**I-75 @ US 41/US 76/SR 3 (Rocky Face)
Interchange Reconstruction**

NH-0000-00(931)

Whitfield County

**Value Engineering Study Report
Design Development Stage**

Sketch
Alt. R-18
Sheet 2 of 4

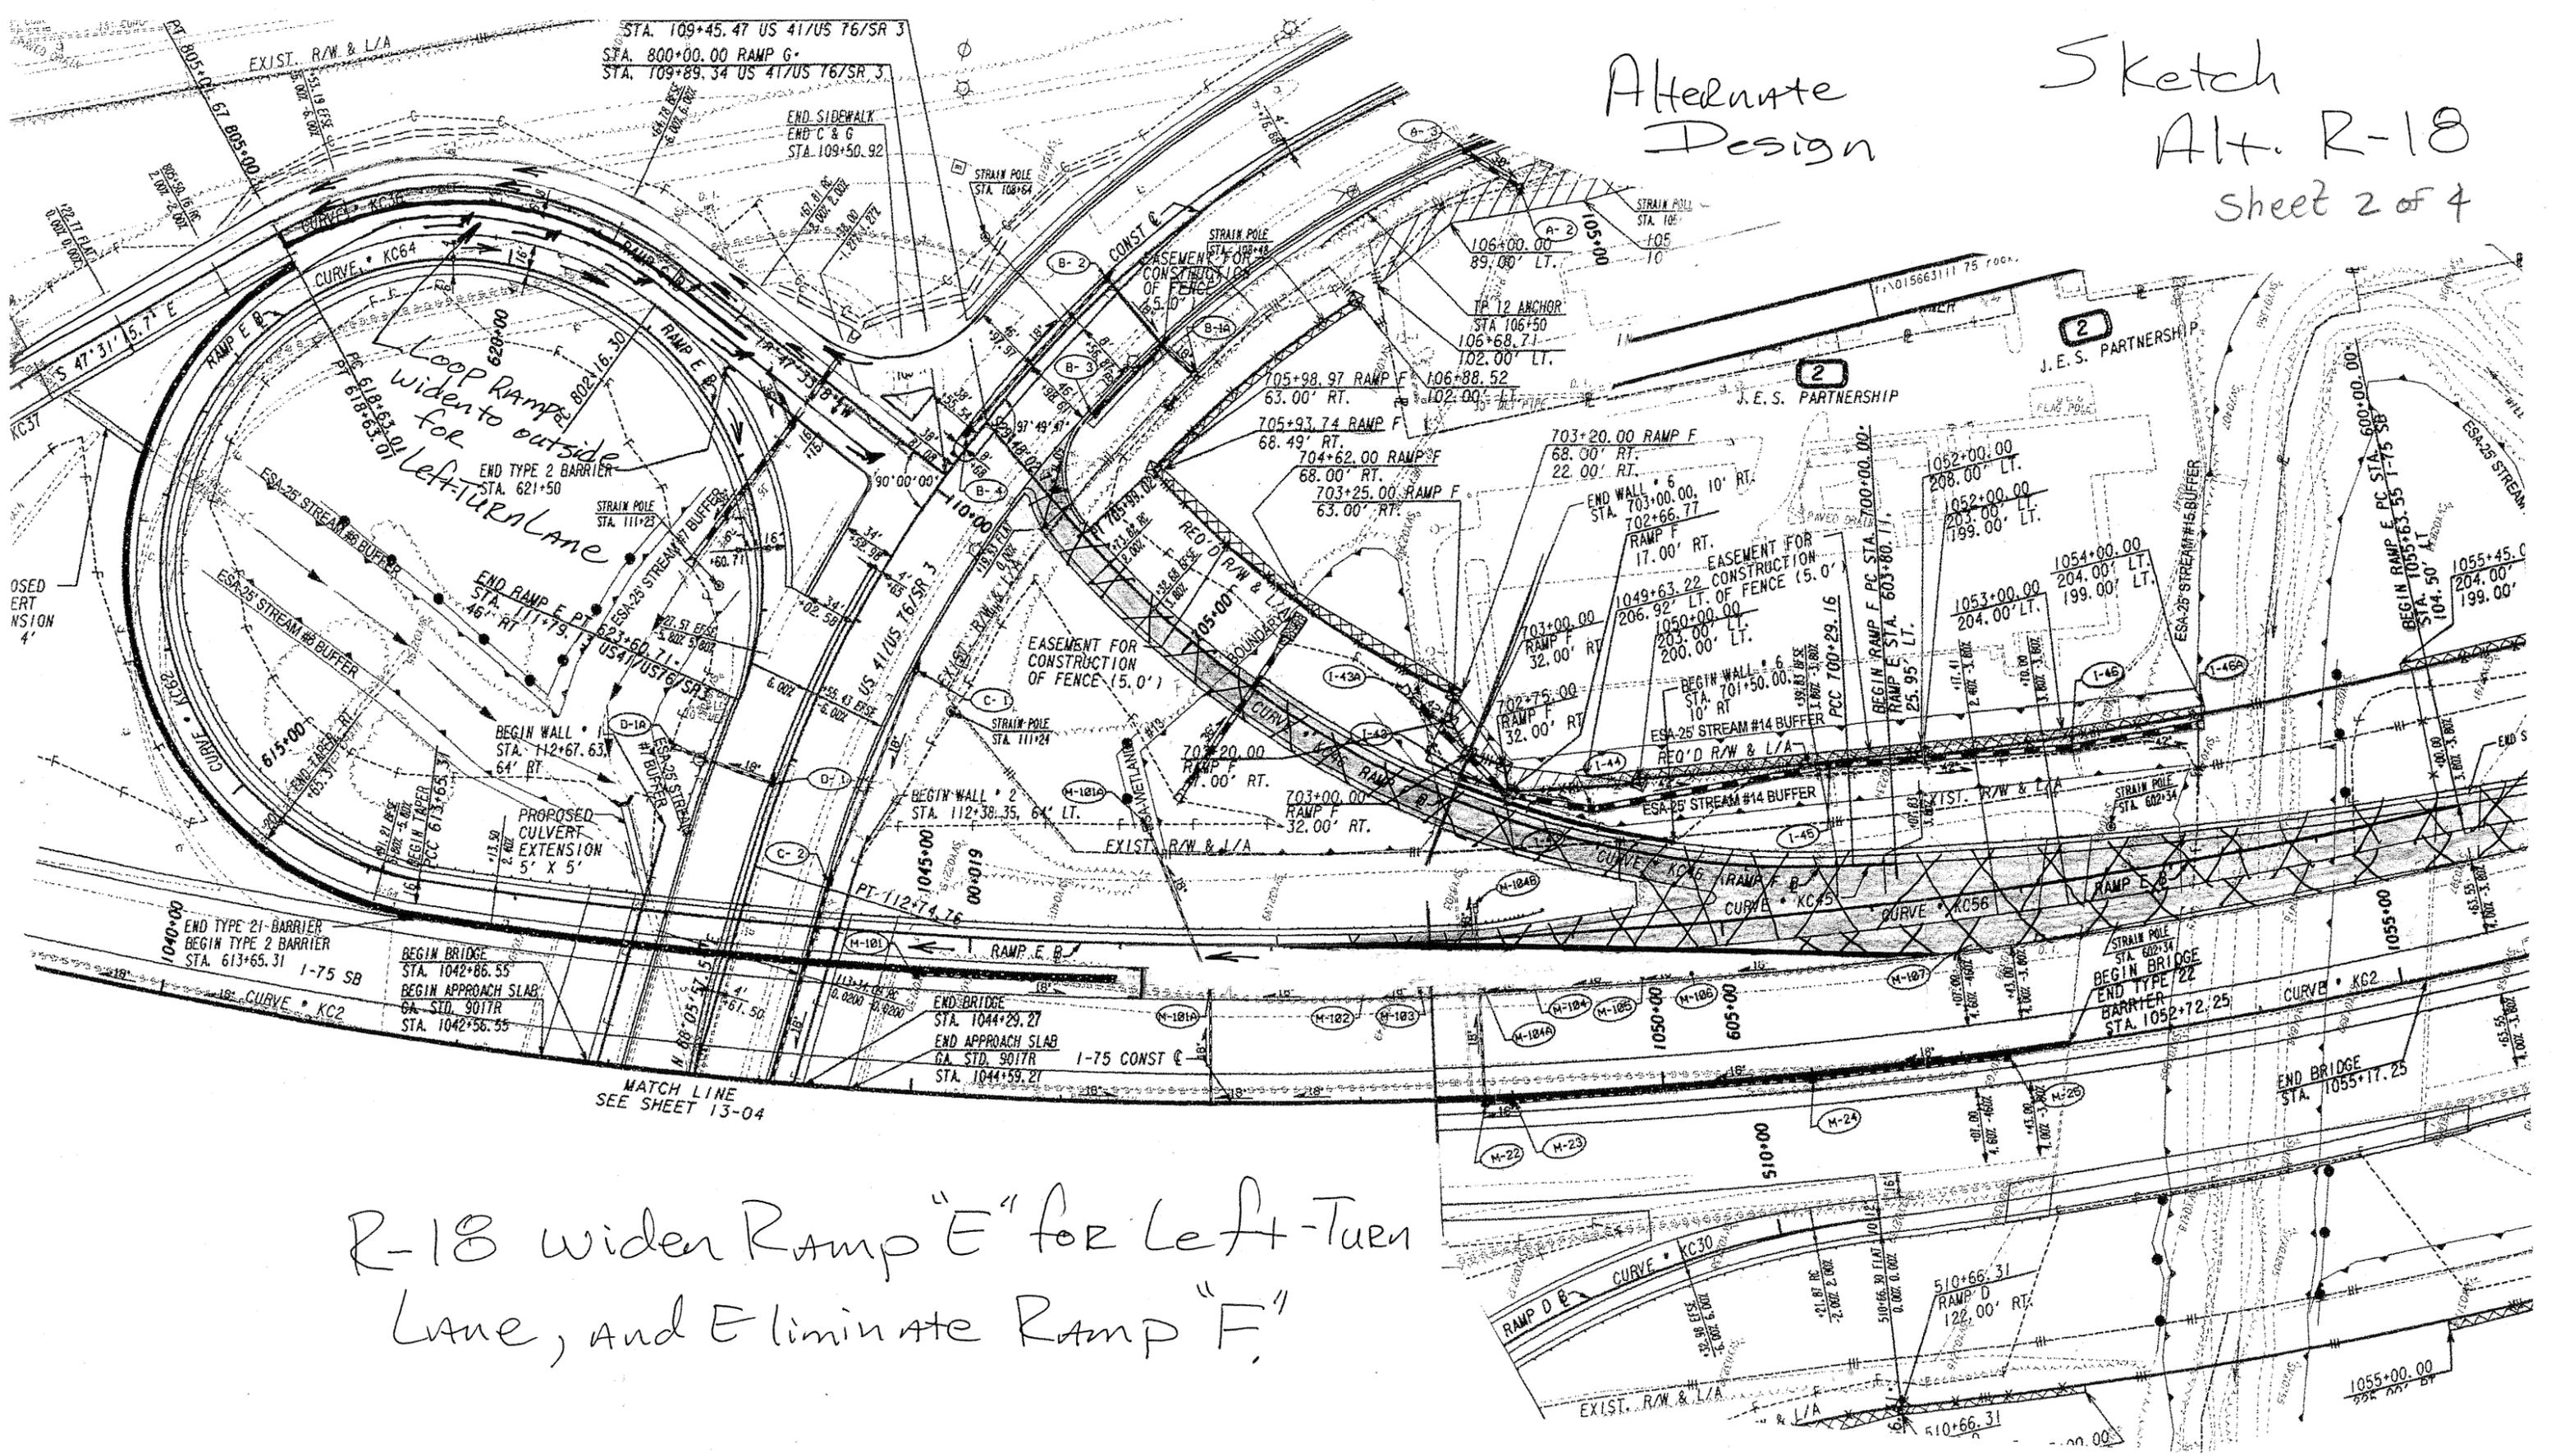
DESCRIPTION: ADD A LEFT TURN LANE TO RAMP E AND ELIMINATE RAMP F

Add a left-turn lane to Ramp E and eliminate Ramp F.

US 41/SR 3 westbound is projected to see 110 vehicles per hour (VPH) in the AM and 238 VPH in the PM for design year 2032. This volume of traffic could be accommodated with an acceptable level of service by widening the new alignment for Ramp E. Eliminating Ramp F would provide a substantial cost savings and would justify redesign of Ramp E.

R-18 widen Ramp "E" for Left-Turn Lane, and Eliminate Ramp "F"

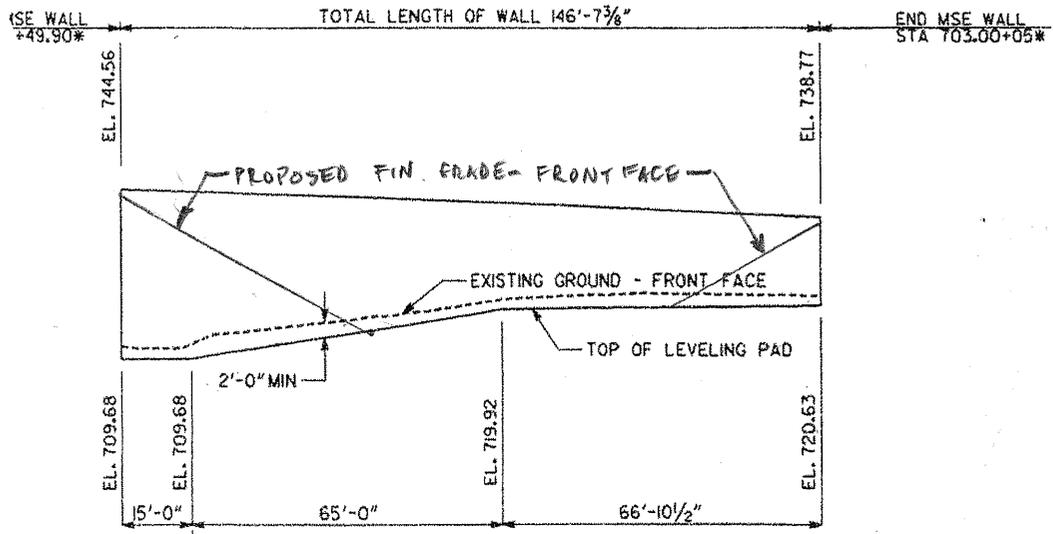
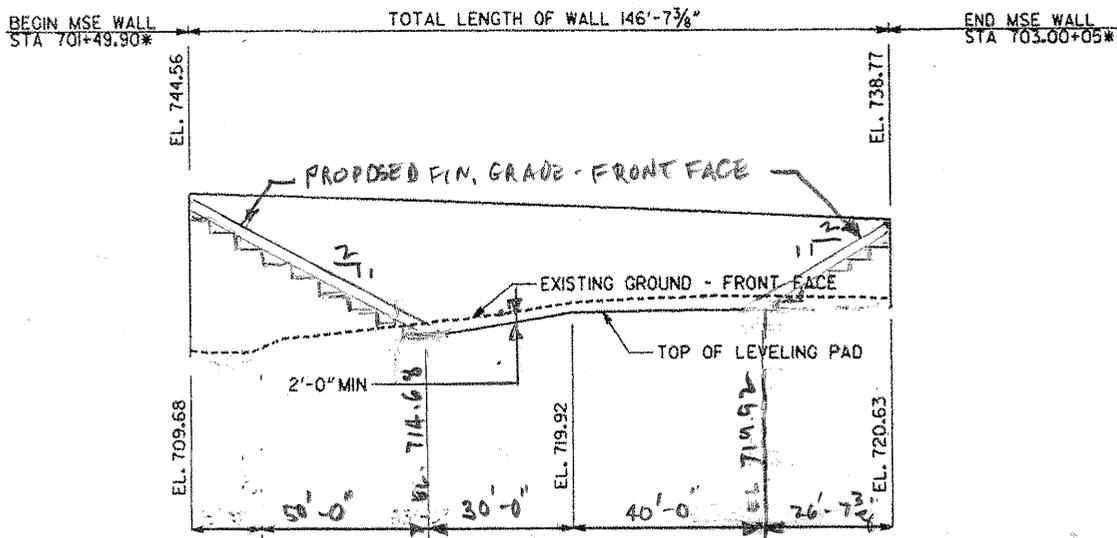
ORIGINAL DESIGN
ELEVATION

ALTERNATIVE DESIGN
ELEVATION

TYPICAL SECTION - STAGE III

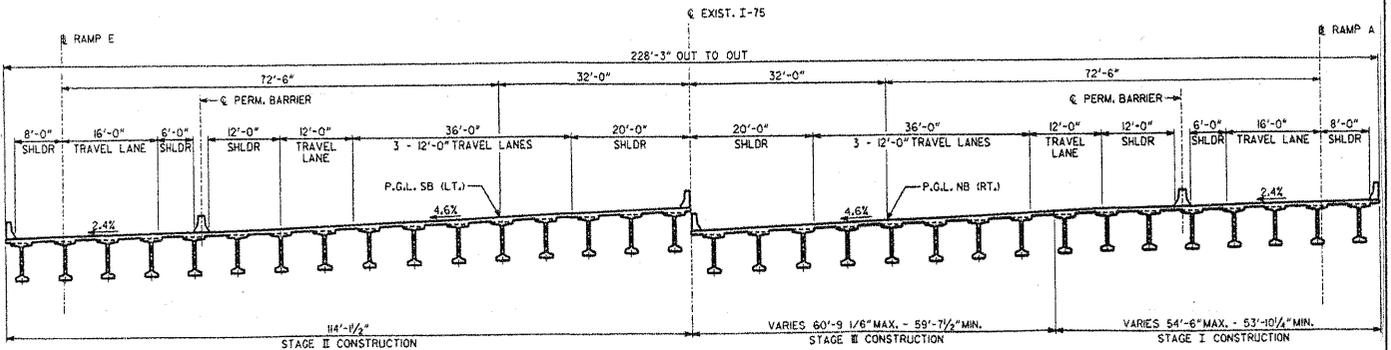
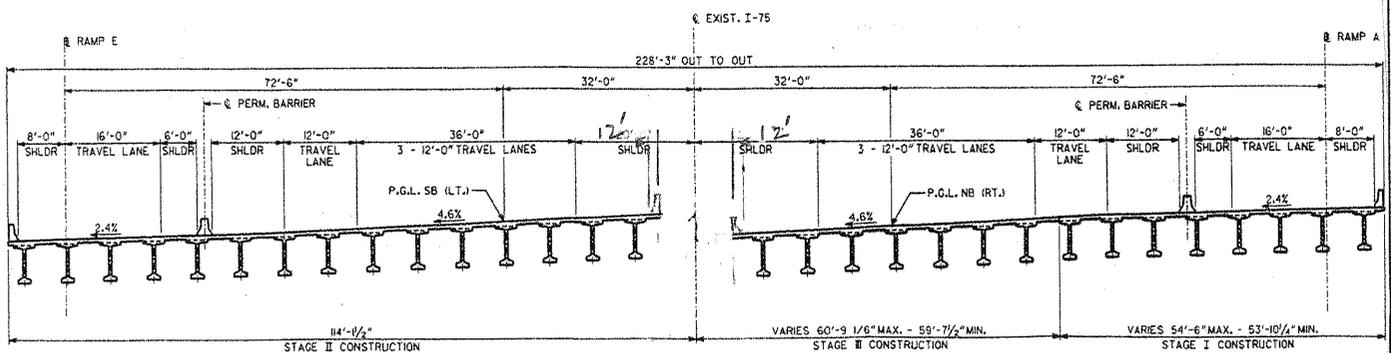
ORIGINAL DESIGN

ALTERNATIVE DESIGN

TS-22
 US 41 / SR 3
 TANGENT SECTION
 N. T. S.
 STA. 112+00 +/- TO STA. 116+50 +/-

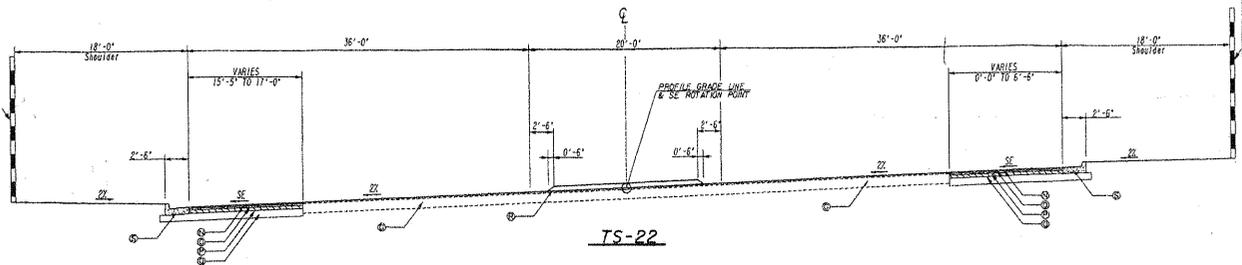
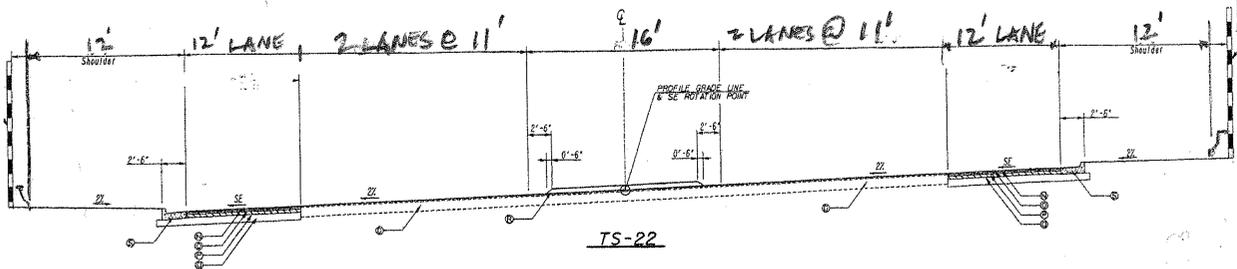
- Provide 12-foot-wide outside shoulders with a barrier at the face of the wall
- Provide a 12-foot-wide outside lane,
- Provide two 11-foot-wide inside lanes,
- Provide a 16-foot-wide median

ORIGINAL DESIGN

TYPICAL SECTION

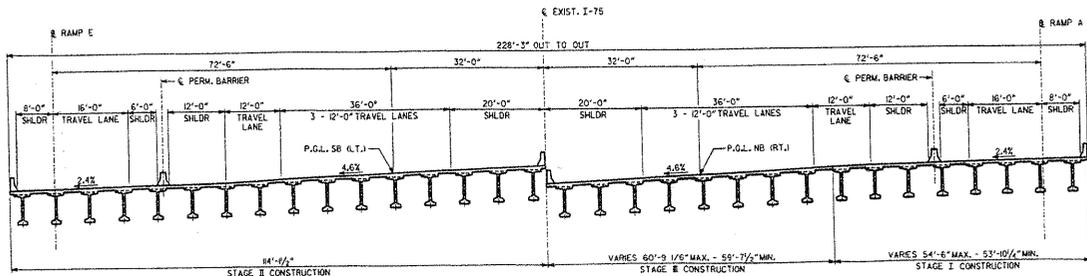
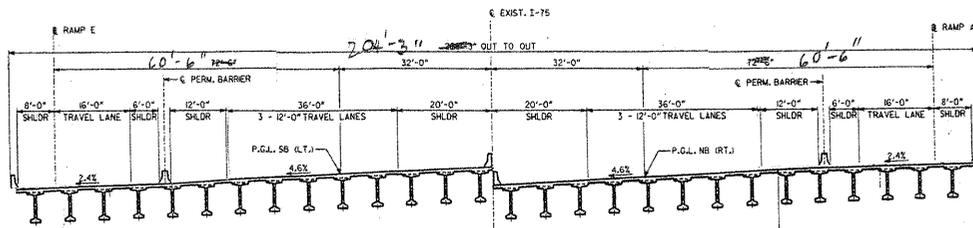
- Higher cost to add a fourth lane later

I-75 is currently operating at level of service "C." Improving the ramps will solve the problem and eliminate the need to widen I-75 to four lanes per side.
